SUBJECT: DONALD C. COOK NUCLEAR PLANT, UNITS 1 AND 2 - AMENDMENT NOS. 169
AND 152 TO FACILITY OPERATING LICENSE NOS. DPR-58 AND DPR-74
(TAC NOS. M80615 AND M80616)

AMENDMENT NO. 169 TO FACILITY OPERATING LICENSE NO. DPR-58-D. C. COOK
AMENDMENT NO. 152 TO FACILITY OPERATING LICENSE NO. DPR-74-D. C. COOK

SAFETY EVALUATION BY THE OFFICE OF NUCLEAR REACTOR REGULATION
RELATED TO AMENDMENT NO. 169 TO FACILITY OPERATING LICENSE NO. DPR-58
AND AMENDMENT NO. 152 TO FACILITY OPERATING LICENSE NO. DPR-74
INDIANA MICHIGAN POWER COMPANY
DONALD C. COOK NUCLEAR PLANT, UNIT NOS. 1 AND 2
DOCKET NOS. 50-315 AND 50-316

FIGURE 5.6-1: Normal Storage Pattern (Mixed Three Zone)

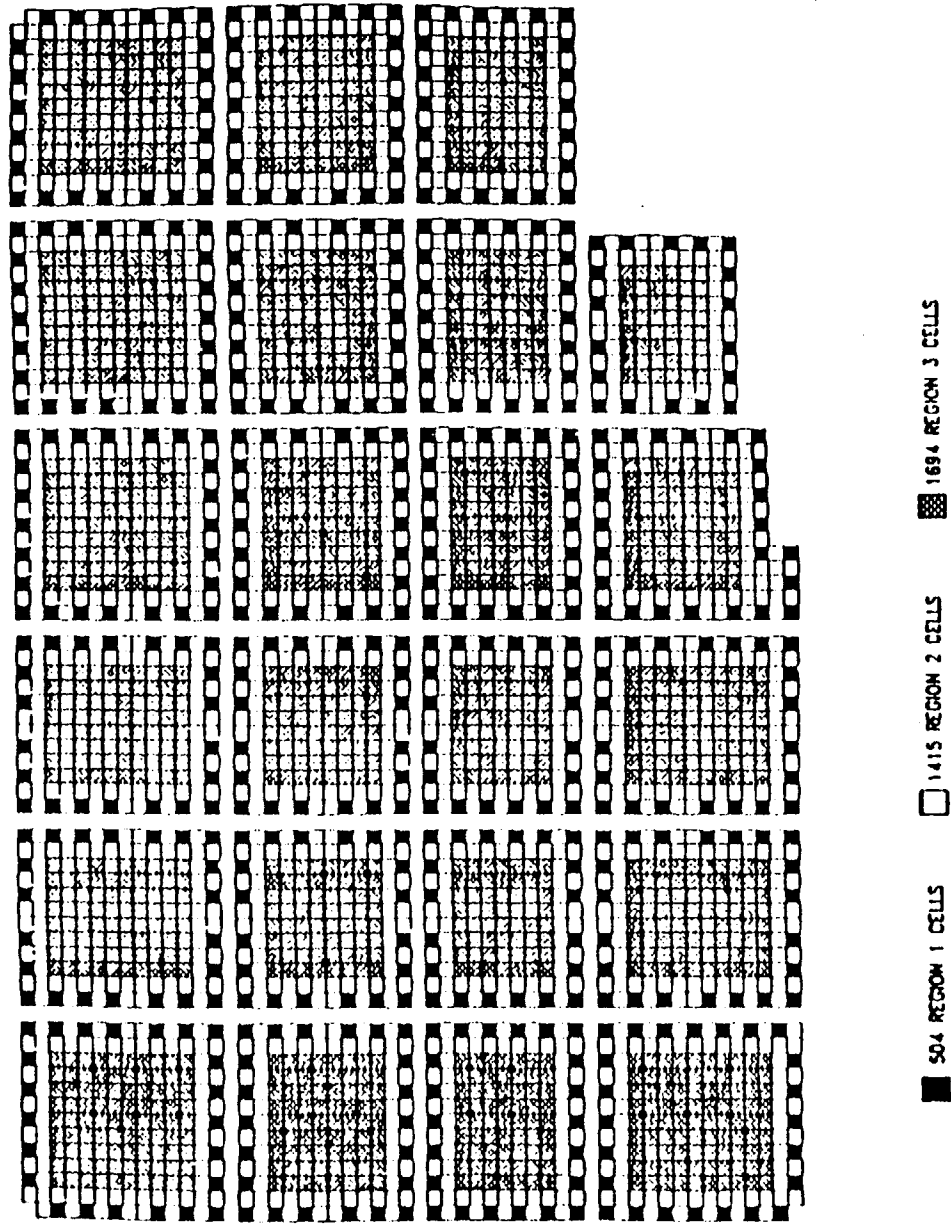
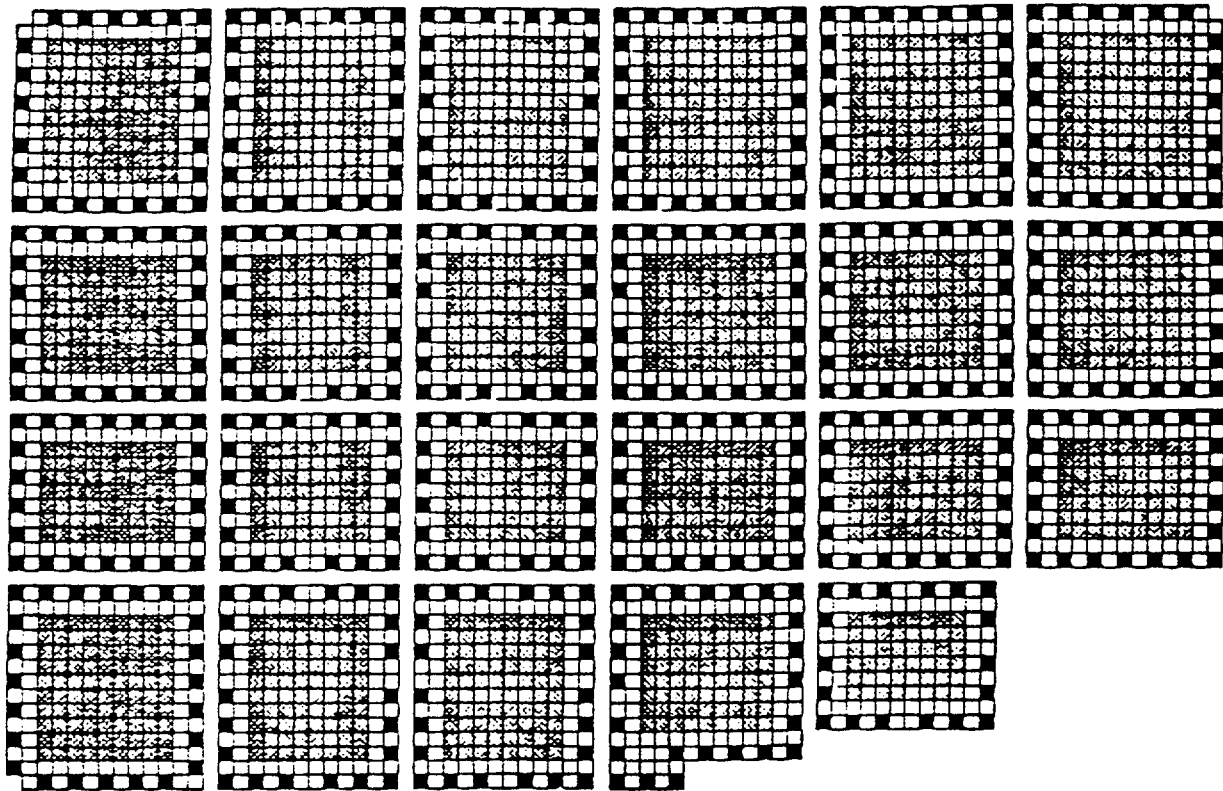
Two options for storage patterns are provided as Figures 5.6-1 and 5.6-2 of the proposed TS. A graphical representation of the regional definitions is provided as Figure 5.6-3 of the proposed TS.

Figure 5.6-3: Acceptable Burnup Domain in Regions 2 & 3

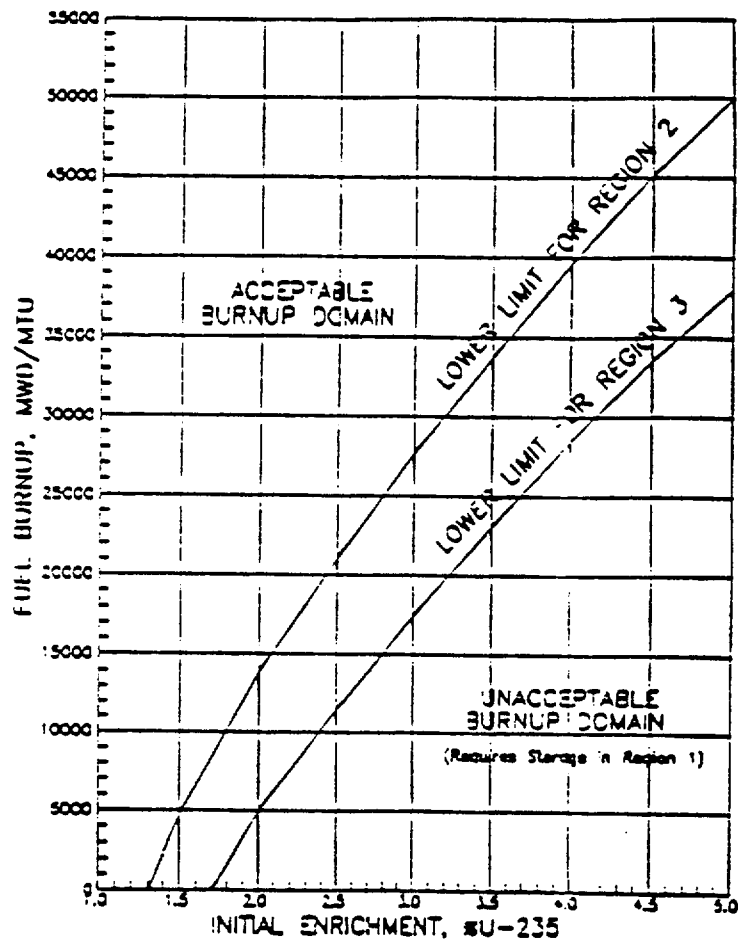
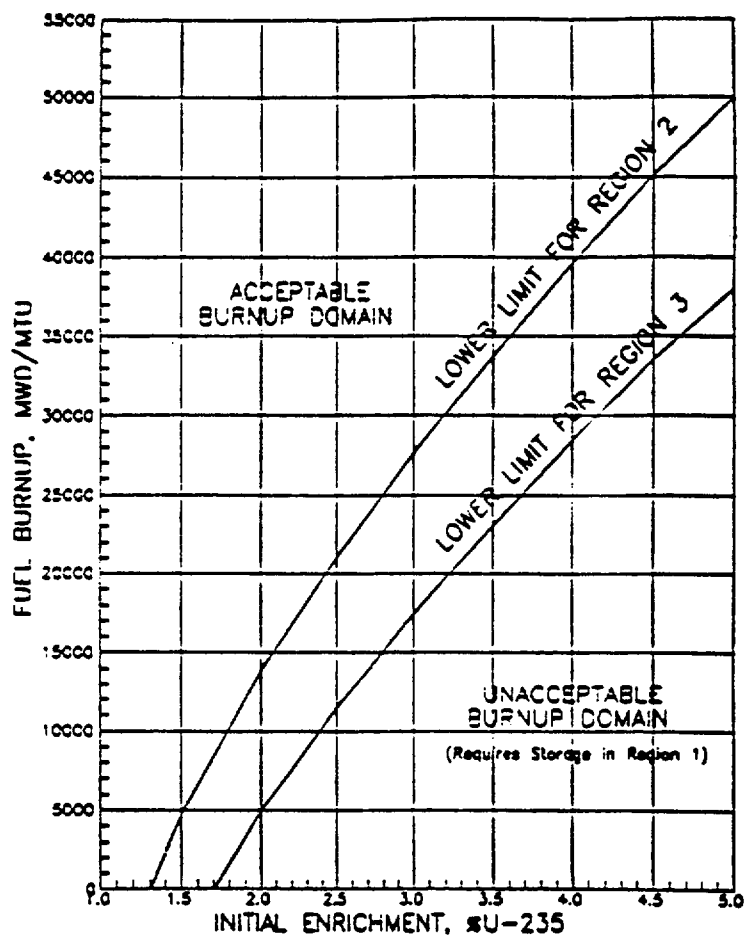
The equivalent reactivity criteria for Region 2 and Region 3 is defined via the following equations and graphically depicted in Figure 5.6-3.
